RFB NO. 108049- ADDENDUM NO. 2

#### TENANT IMPROVEMENTS

#### THIRD FLOOR, CITY-COUNTY BUILDING

TENANT IMPROVEMENTS
THIRD FLOOR
CITY-COUNTY BUILDING
210 MARTIN LUTHER KING,
JR. BLVD., MADISON, WI

AD2.A2.0.1

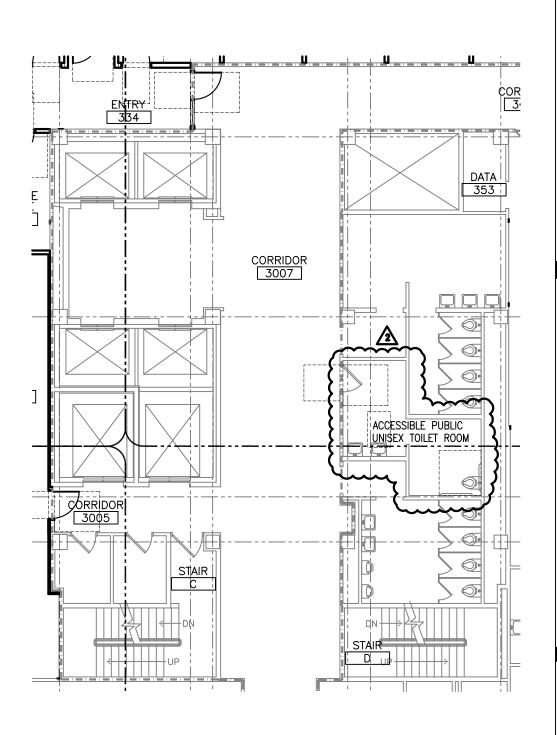
Modify current Sheet A2.0 as shown on AD2.A2.0.1, issued with this Addendum. Added notation of accessible public toilet room.

AD2.A2.1.1

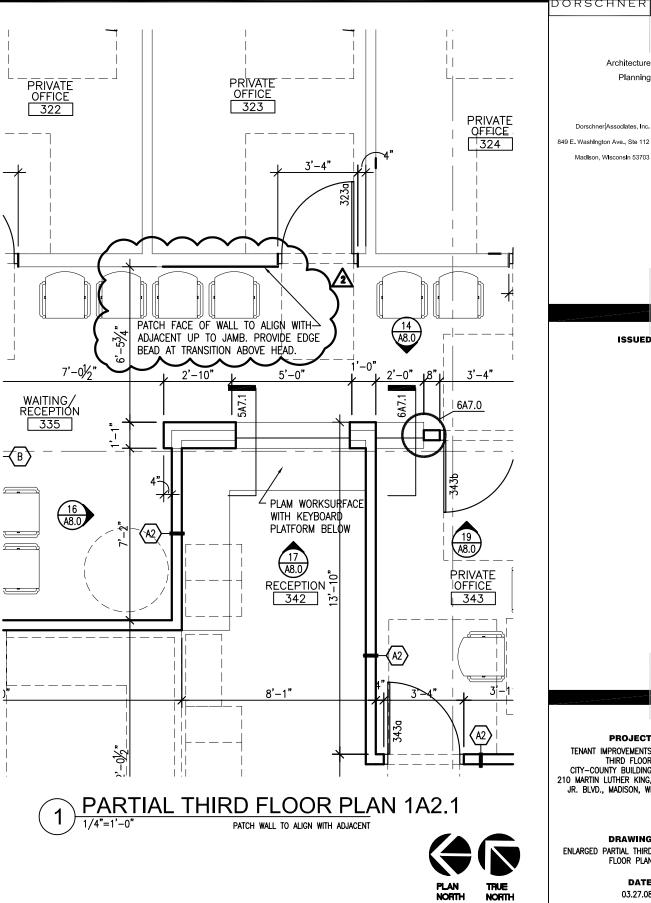
Modify current Sheet A2.1 as shown on AD2.A2.1.1, issued with this Addendum. Revision to patch wall to align with adjacent in Waiting/Reception 335.

AD2.A2.2.1

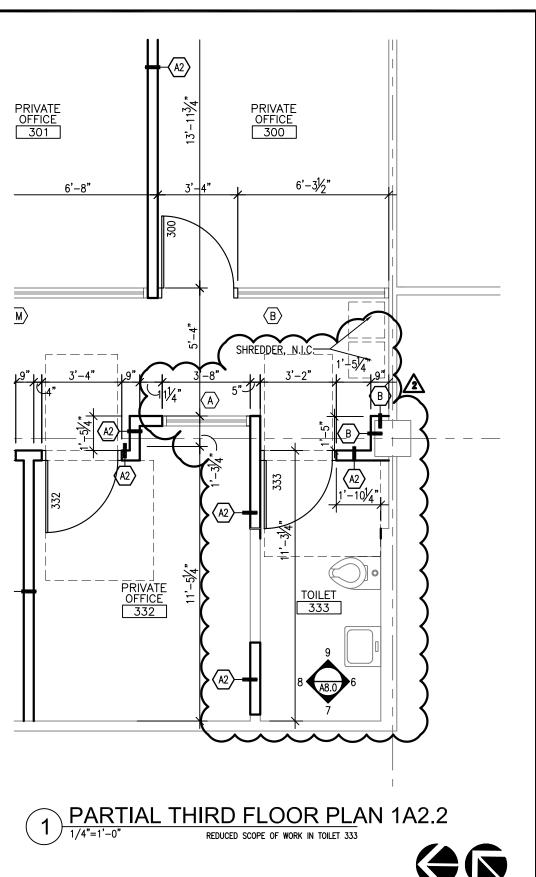
Modify current Sheet A2.2 as shown on AD2.A2.2.1, issued with this Addendum. Reduced scope of work in Toilet 333.

AD2.A2.2.2

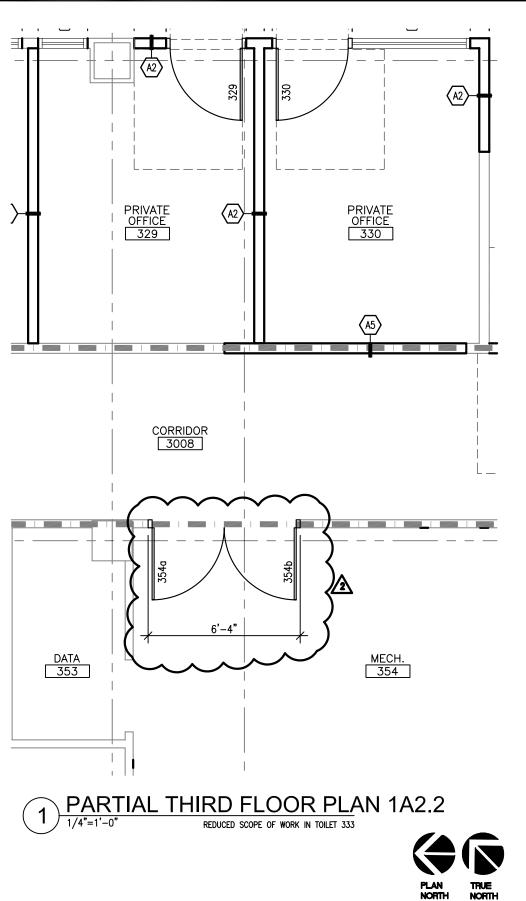
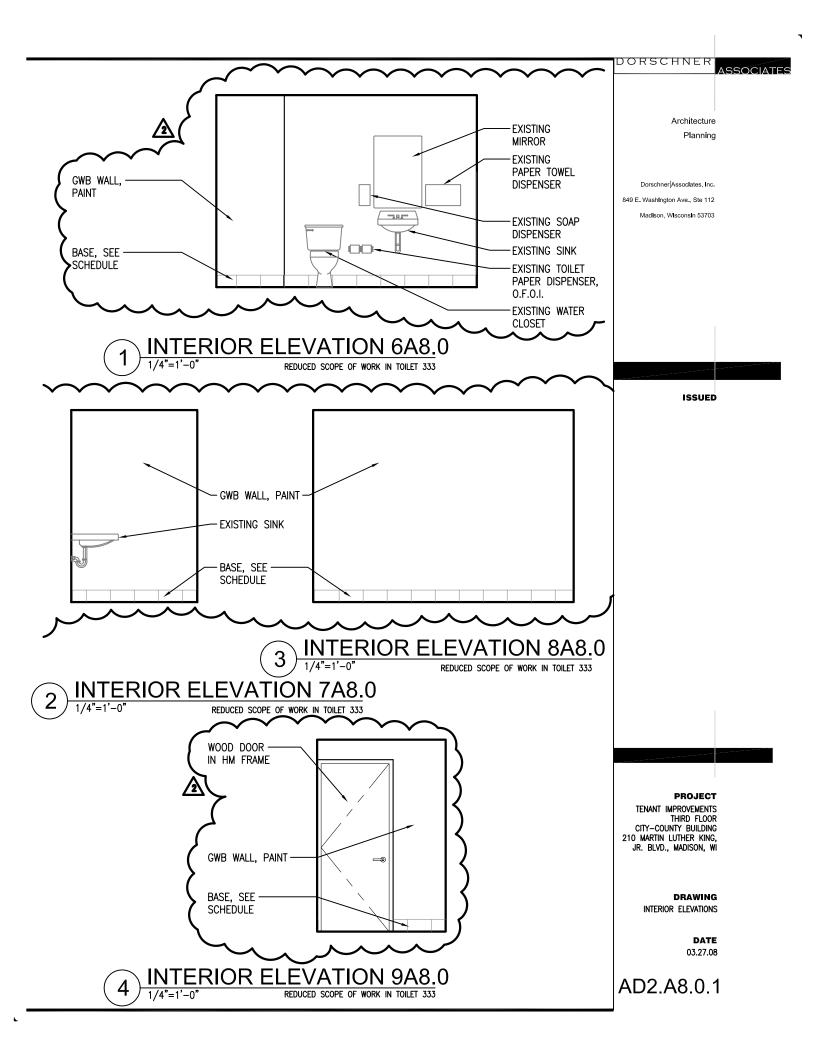
Modify current Sheet A2.2 as shown on AD2.A2.2.2, issued with this Addendum. Added doors 354a and 354b.

AD2.E2.0.1

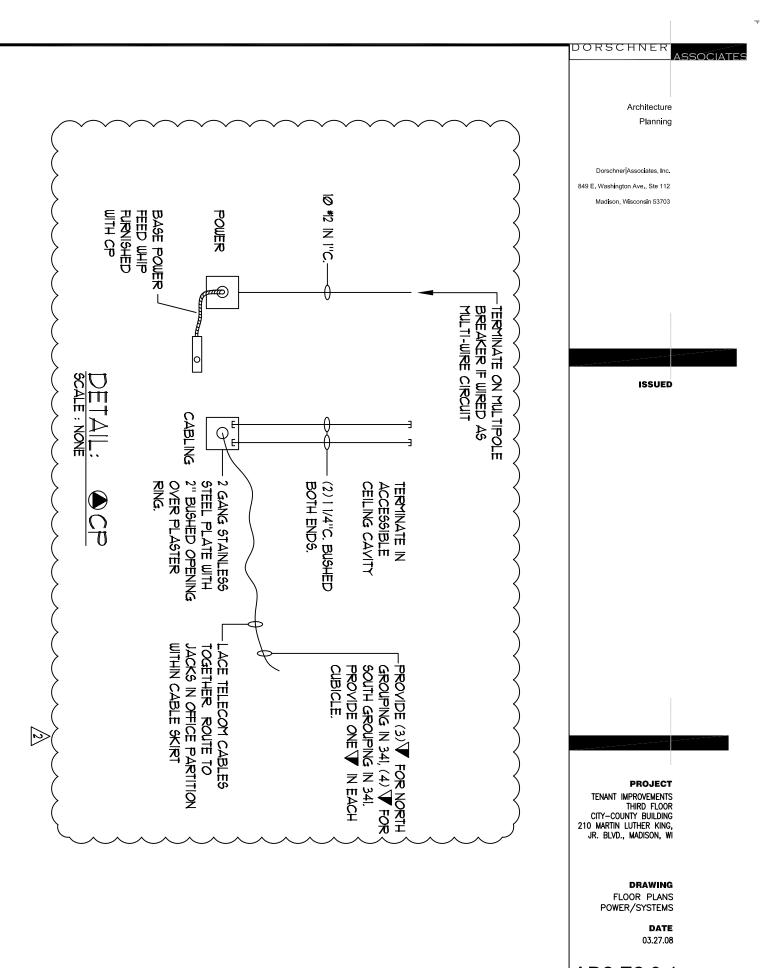
Add Wiring Detail-Special Outlet CP per AD2.E2.0.1, issued with this addendum.
